CRIME IMPACT STATEMENT

87 ROCHDALE ROAD, MANCHESTER

RESIDENTIAL (14 no. HOUSES & 223 no. APARTMENTS) & RETAIL (121sqm.)

REFERENCE: 2010/1094/CIS/01

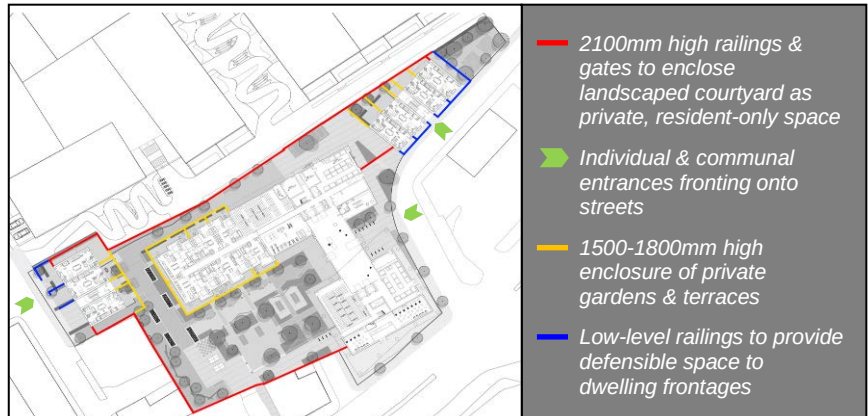
- 3.3.1 The proposed landscaped courtyard is partially enclosed by Block 1, 2 & 3 and is located to the side/rear of the existing off-license and public house buildings, resulting in it being a partially hidden space that cannot be clearly seen from the street. The surrounding buildings feature ground floor residential windows and patio doors/external terraces accessible from the courtyard - leaving them vulnerable to being left insecure by the residents, to damage and to being forced open and could be used by offenders to gain unauthorised access to both the apartments/duplexes themselves, as well as the rest of the buildings (by circumnavigating the access-controlled main entrances). The area also includes benches, picnic tables and play equipment, which could foster loitering/gathering, nuisance, anti-social behaviour and mis-use (such as rough sleeping) if left publicly accessible. For these reasons, it is highly recommended that the landscaped areas to the sides and rear of the buildings are securely enclosed and defined as private, resident-only spaces in order to prevent unauthorised access and limited all public access to the more visible elevations of the scheme, where surveillance opportunities are maximised (see illustration opposite & Section 4.5 for more information). The dedicated private gardens and terraces to the ground floor units within the Blocks should also be enclosed to clearly define them as in ownership/control of those residents and to limit access through any potentially insecure patio doors. The frontages of the ground floor duplex units within Blocks 3 & 4 should be protected by some defensible space, defined by low level railings and (ideally) pedestrian/vehicular gates, clearly defining them as entirely separate from the street, in ownership/control of the residents themselves. Boundary treatments to the front of units should be carefully considered to ensure they adequately define the space without impeding surveillance or providing features that could be comfortably sat on/lent against, to the nuisance and intimidation of residents (also see Section 4.5). The 'front garden' spaces should be well-lit (see Section 4.7) and the external entrance doors should be security-certified and fitted with split-spindles, essentially meaning they are key only entry and are locked from the exterior of the dwelling when shut, ensuring that they cannot be left insecure (see Section 4.1).

- 3.3.2 As proposed, Block 3 has individual and communal entrances off Gould Street and the landscaped courtyard, leaving all elevations of the building accessible and potentially vulnerable. It is highly recommended that all of the duplex units within the building are accessed via individual or communal entrances off Gould Street, where surveillance opportunities from the street are maximised, allowing the sides and rear of the building to be enclosed as private space. If it is absolutely unachievable for all of the duplex units to be accessed off the street and some must be accessed from the rear of the building, any visitors (as well as residents) should enter the site via the concierge-controlled entrance lobby between Blocks 1 & 2. Secure access controls will be critical to this strategy to ensure that visitors are not allowed to wander uncontrolled between buildings and around the private courtyard. The reception desk within the main entrance lobby should be staffed by a 24-hour concierge, who should oversee, control and direct all visitor access/egress to/from Blocks 1, 2 & 3 at all times (see Section 4.1), as well as provide formal surveillance over the public realm and the private courtyard. The concierge should greet visitors, contact residents to vet them and then remotely control access through the internal entrance doorsets off the entrance lobby into Blocks 1 & 2 and the doors through into landscaped courtyard (for visitors to Block 3). Once the visitor reaches Block 3, the communal entrance should be operated via an audio access control system, allowing residents to confirm the identity of the caller and remotely allow them access into the building. The communal entrance to Block 4 should operate via its own video access control system in the absence of a concierge. There should also be a secure system

- 3.3.3 The surrounding land to the north and east of the site is currently occupied by temporary pay & display/contract car parks on vacant sites, along the on-street parking along Clive Street. The general lack of activity/footfall/surveillance in these areas, as well as poor lighting levels and the informal nature of the facilities themselves, mean that vehicles parked for long periods of time can be vulnerable to damage and theft. Although these areas are likely to be developed in the future, in the short-term, this context must be considered. The 4 no. surface parking spaces at the north-eastern end of site will leave the parked vehicles particularly vulnerable in this high vehicle crime area. These parking spaces are remote from the dwellings they serve and do not allow many of the residents to directly overlook their own vehicles - leaving them vulnerable. Given the existing on-street parking along Clive Street, they could also be vulnerable to being mis-used or blocked during the day. Where resident's parked vehicles cannot be secured within a secure garage/parking facility, they should be located directly in front of the dwellings they serve (ideally in-curtilage and separate from the street), to allow the owners themselves to act as 'capable guardians' overlooking their own immediately adjacent vehicles. If it is not possible to relocate these spaces, they should be defined for short-term visitor use only (with signage/enforcement measures) to ensure they are not be used on a long-term basis by residents - leaving their vehicles vulnerable (particularly at night).

- 3.3.4 Given the high levels of vehicle crime in the local area, access to the proposed basement level car park must also be robustly secured, controlled and maintained, in order to prevent unauthorised access. The vehicular entrance to the car park (off Gould Street) should be fitted with a high-speed automatic shutter (to reduce the potential for tailgating), operated by resident key fob/proximity reader with no automatic egress (i.e. access control both 'in' and 'out') so that criminals cannot gain access to the area, attack the vehicles and escape (see Section 4.6). The internal pedestrian entrance off the car park should be security-certified and access-controlled (see Section 4.1) to ensure that if unauthorised access is gained to this areas (e.g. via tailgating, forcing open shutters etc.), further access to the upper floors of the building is prevented.

- ☐ The sides and rears of the buildings, including the landscaped courtyard, should be defined and enclosed as a private, resident-only space with 2100mm high walls or railings and lockable gates (as shown within Section 3.3). Care should be taken to ensure that panels are fixed securely to the posts and that any level changes do not inadvertently facilitate climbing or leave large gaps underneath the panels/gates. There should be no centrally located horizontal bars to aid climbing and there should be no immediately adjacent climbing aids, such as low walls, projecting elements of the building, lighting columns, junction boxes etc, which may form a climbing aid. Any boundaries formed by a combination of walls and railings should have railing panels that are fixed flush with the outer skin of the brickwork below, leaving no steps/gaps that would provide a climbing aid.

- ☐ Any pedestrian gates to private space should also be 2100mm high, self-closing and self-locking, operated by staff/resident key or fob on access and egress. They should also be located away from other climbing aids, such as low walls, planters/street furniture, lighting columns etc. Mid-point horizontal elements, exposed hinges and large sliding bolt apertures/locking points to any gates should be avoided, or fitted with shrouding/protective plates to avoid the creation of footholds (see illustration opposite).

- 
- ☐ The private gardens/terraces to the ground floor duplex units and apartments within the 2100mm secure perimeter shown be defined with 1500-1800mm high railings or glazed balustrades and planting.

- ☐ The frontages of the duplexes fronting onto Gould Street and Clive Street should be protected by some defensible space defined by low-level railings and ideally pedestrian/vehicular gates, to an approximate height of 1200mm (see illustration within Section 3.3), in order to provide some protection and funnel passing pedestrian movement away from residential doors and windows. Any railings should be designed to discourage comfortably sitting on or leaning against them, which could potentially cause nuisance and intimidation to residents.
